RE: Addendum No. 2 – Waller County Bid 25-002 – Construction of Justice Center Vehicle Maintenance Garage

ADDENDUM #2 July 25, 2025

**Waller County - Vehicle Maintenance Garage 200 Sheriff R Glenn Smith Dr.
Hempstead, TX 77445**

Mezzanine Framing Plan

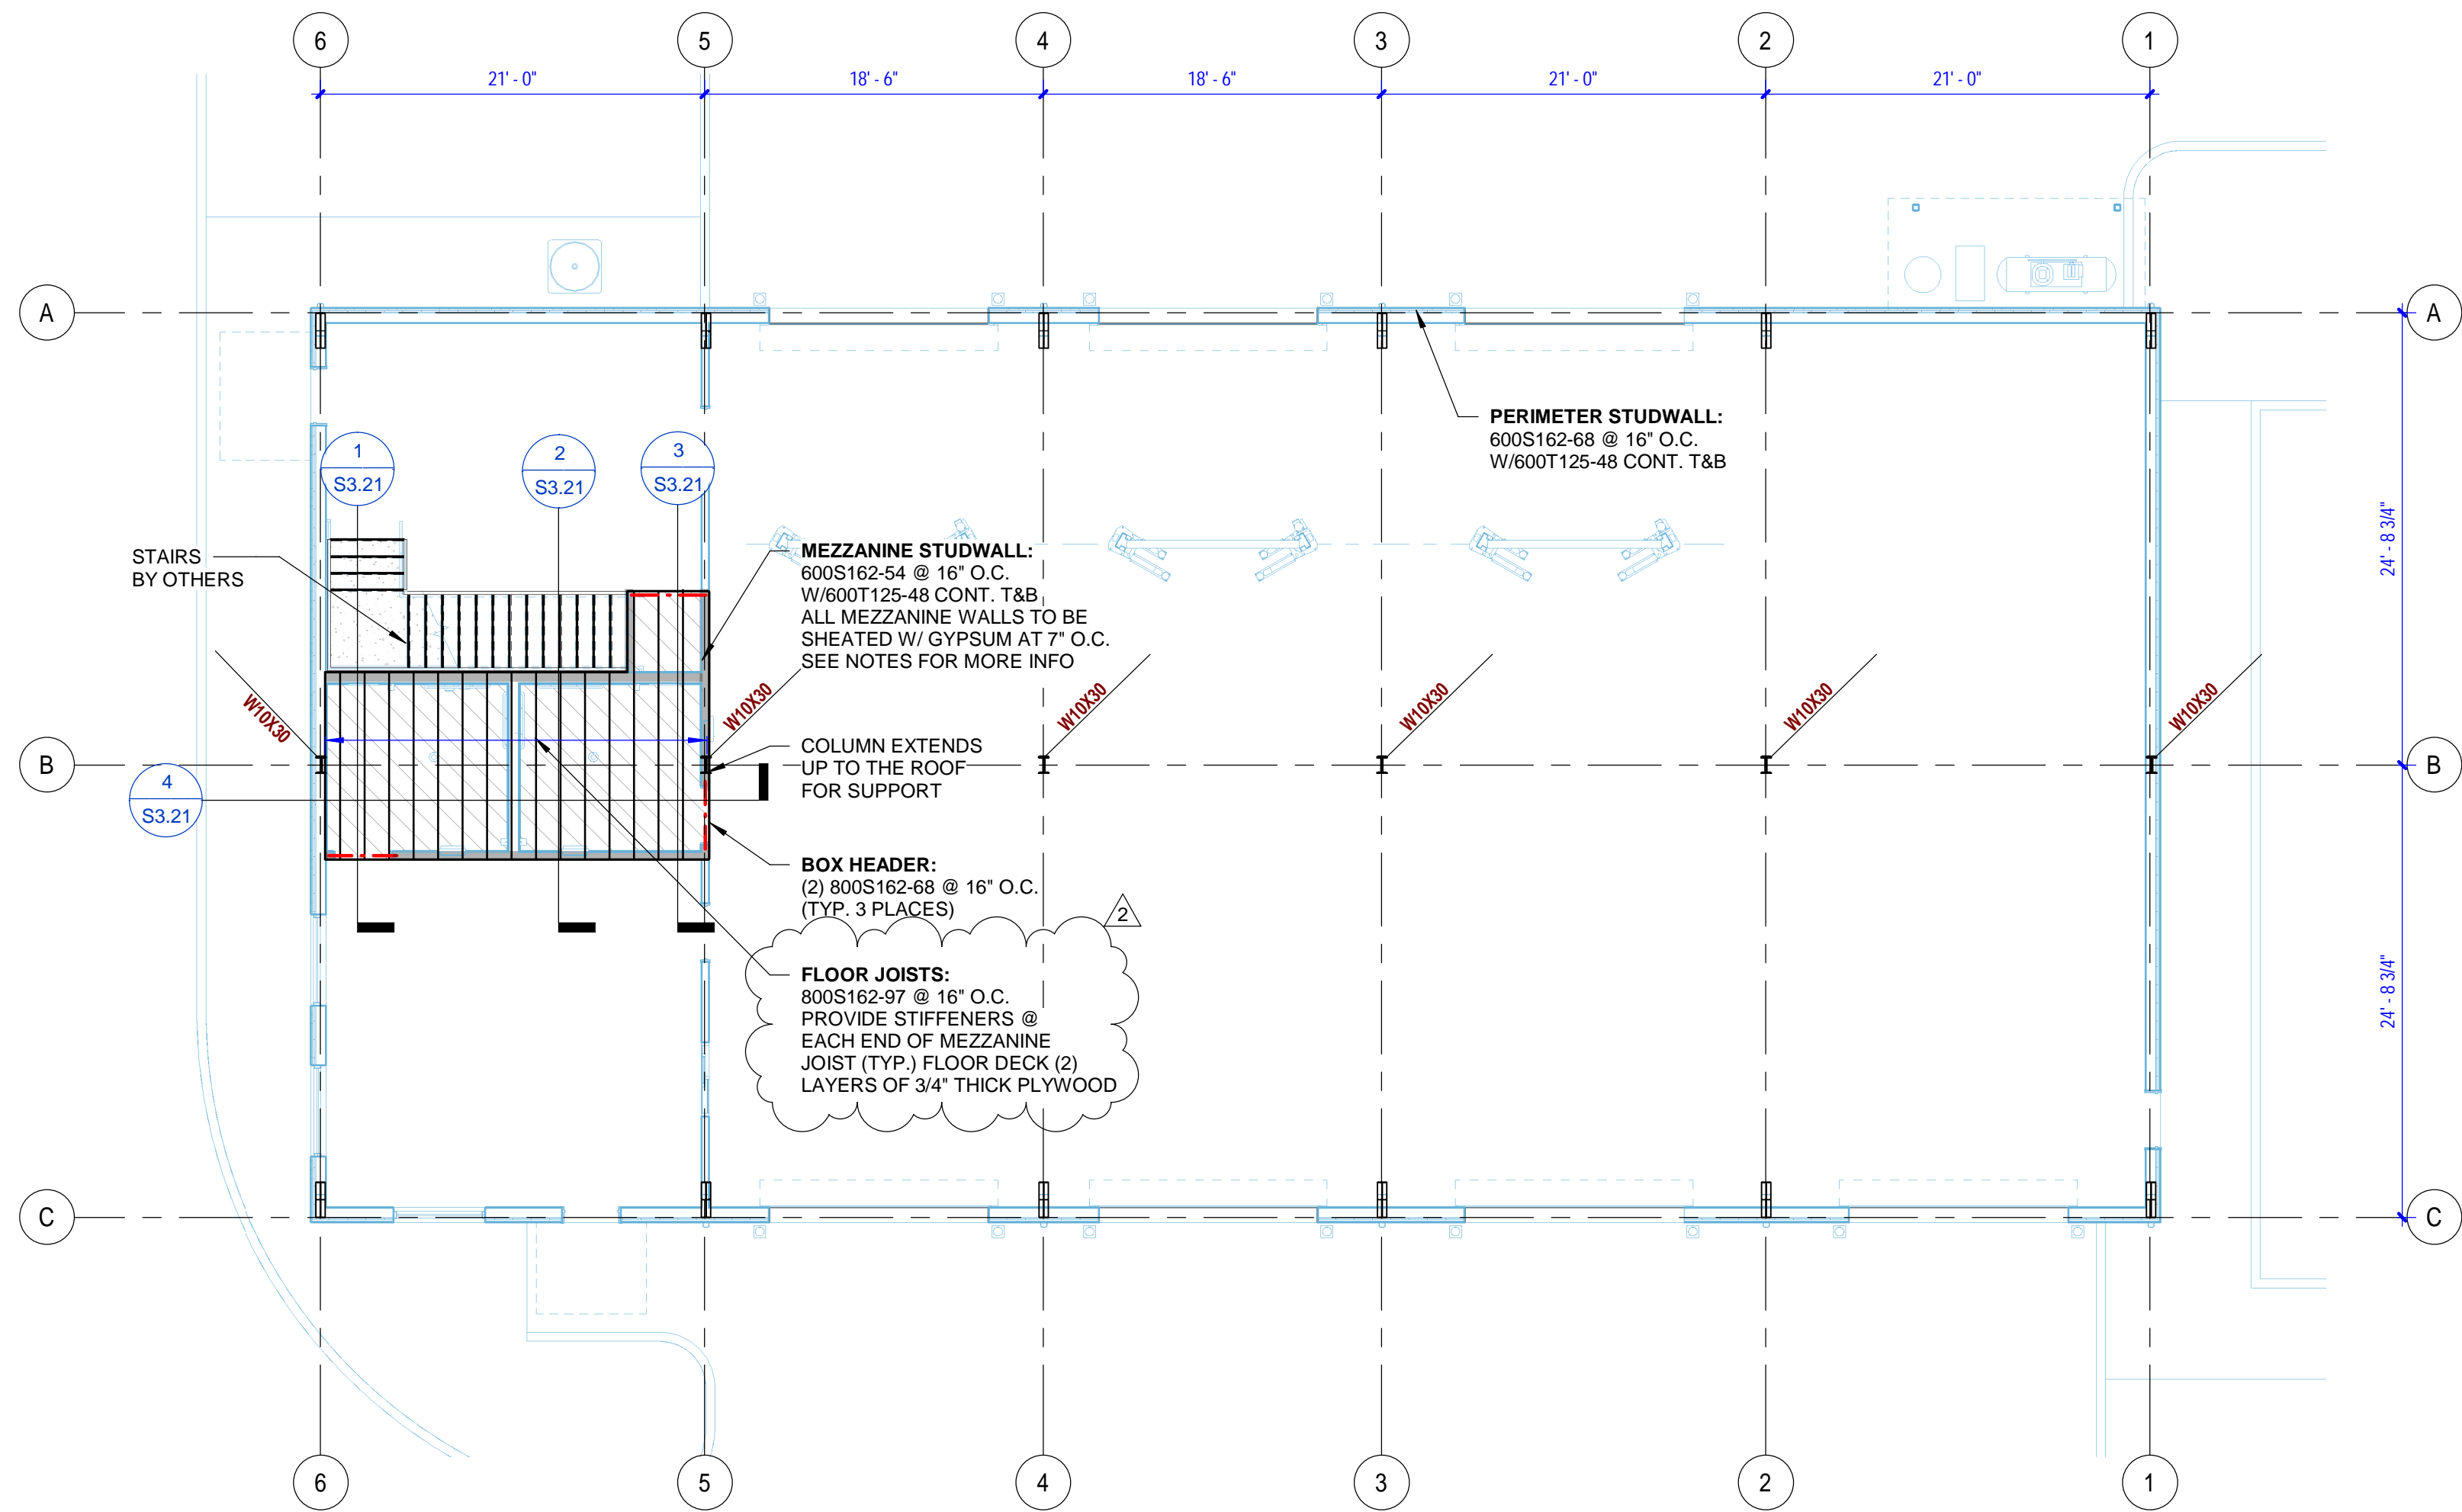
- 1. ... Mezzanine... thickness not shown- please clarify.**

Question 2: Slab, pavement, and mezzanine concrete thickness not shown – please clarify.

1. Sheet S1-10 – Added slab notes. Added a 2nd layer of floor sheathing to the mezzanine level.
2. Sheet S3.21 - Added a 2nd layer of floor sheathing to the mezzanine level on details 1 -

- MEZZANINE SHEATHER WITH GYPSUM BOARD SHEAR-WALL:**
1. GYPSUM BOARD (GYP) TO BE 1/2" THICK MINIMUM.
 2. ALL GYP EDGES TO BE ATTACHED TO STRUCTURAL MEMBERS OR BLOCKING AND SCREWED AS SPECIFIED IN THE SHEAR WALL SCHEDULE.
 3. SCREWS ATTACHING GYP SHEATHING TO BE SELF TAPPING SCREWS IN ACCORDANCE WITH ASTM C954 OR ASTM C1002.
 4. STRAP BLOCKING IS TO BE ATTACHED TO THE STEEL FRAMING THEN GYP SHEATHING IS TO BE SCREWED TO THE STRAP. STRAP BLOCKING TO BE MIN. THICKNESS OF 33 MILS AND 1 1/2" WIDE.
 5. SCREW EDGE DISTANCE IS 3/8" MIN.

Answer: 5" thick slab-on-grade reinforced with #3@15"O.C.E.W. The mezzanine decking is not concrete. It is two (2) layers of 3/4" plywood [glued and screwed]. See Addendum #2. Pavement thickness is specified in the Geotechnical Report specification 02210, section 6.8.2 of the geotechnical report.
